Technical Support

Identifying VR140-VR150 Clutch for Replacement

Underhood VR140 / VR150 – Compressor Serial Number starts with P140xxxxxxxxx.

Figure 1

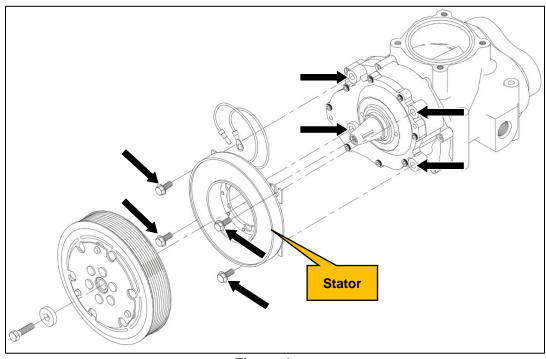
Obsolete clutch with 4 bolt stator mount (P/N: P200039):

• The P200039 is identifiable by the 4 bolts holding the clutch stator to mounting points on the front gear case cover of the compressor. See *Figure 1*.

If a replacement clutch is required for a VR140 or VR150 with the old-style clutch, order kit number A700234, which contains the new-style P200050 clutch and an updated front gear case cover assembly.

Figure 2

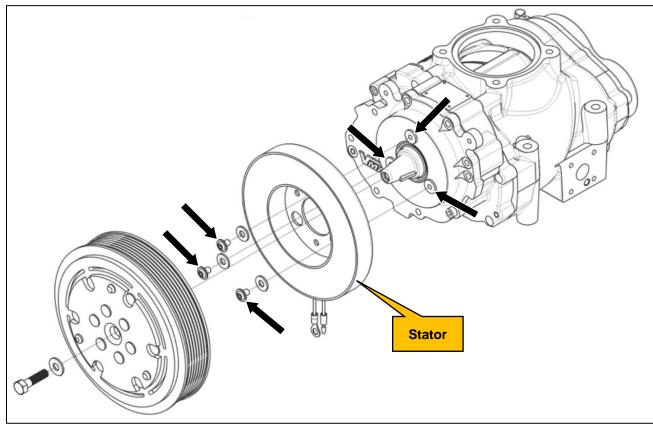
New-Style P200050 clutch with 3 bolt stator mount:

• The new design P200050 clutch is fastened to the compressor gear case using 3 bolts inside the clutch stator. These bolts are not visible when the clutch is assembled. See Figure 2.
